Responses to the comments from Anonymous Reviewer #2

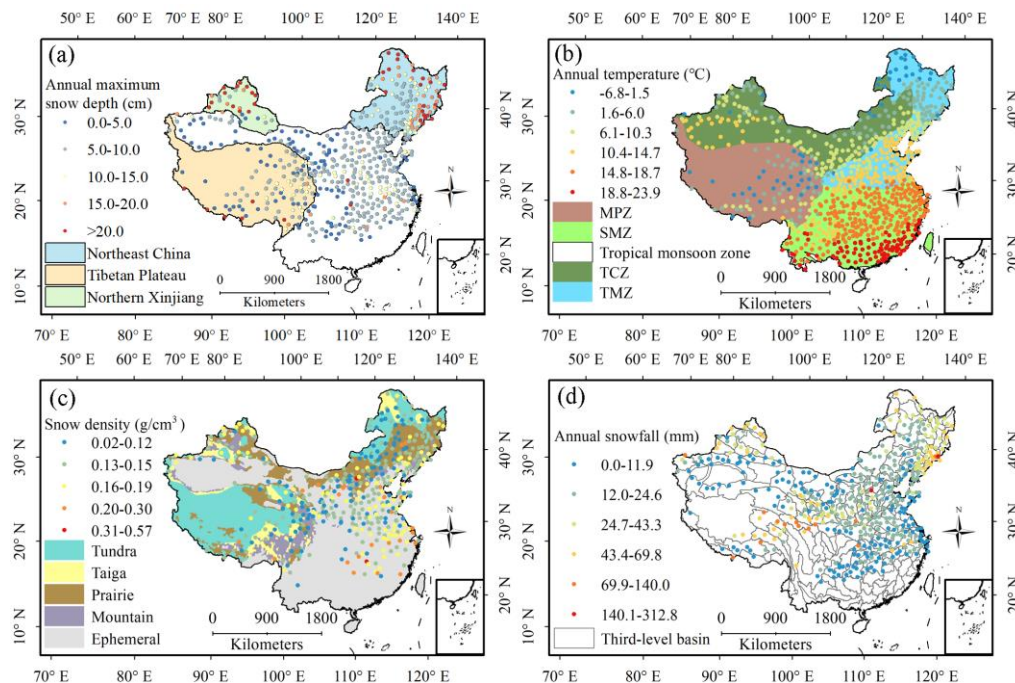
7. Line 93: Figure 1a showed the mean snow depth from 557 meteorological stations in China. The mean snow depth is little significant, and it is better expressed by accumulated snow depth or the maximum snow depth. Figure 1c. Please use 3 as superscript in cm^3 .

Response: Thank you for this comment. We have revised the the mean snow depth to the maximum snow depth in Figure 1a, and we have revised the unit in the Figure 1c. The revised figure is as follows:

Figure S2. The threshold temperature ($^{\circ}\text{C}$) for snowfall (a) and rainfall (b) at 485 meteorological stations in China.

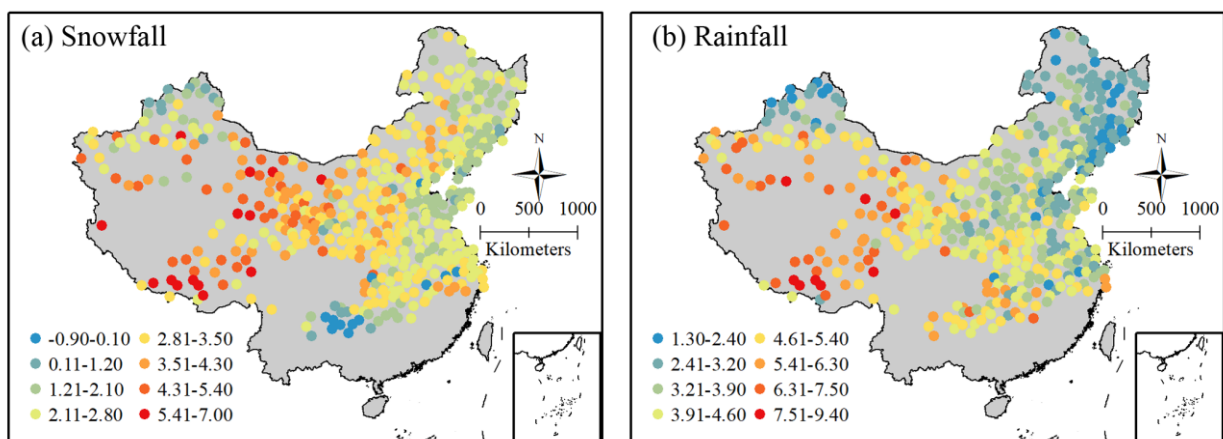
10. Line 115: The threshold temperature in China in this study should be shown in this manuscript by figure or table, or partly shown, I suggest.

Response: Thank you for your suggestion. We have added a figure to the Supplement, and the added figure is as follows:
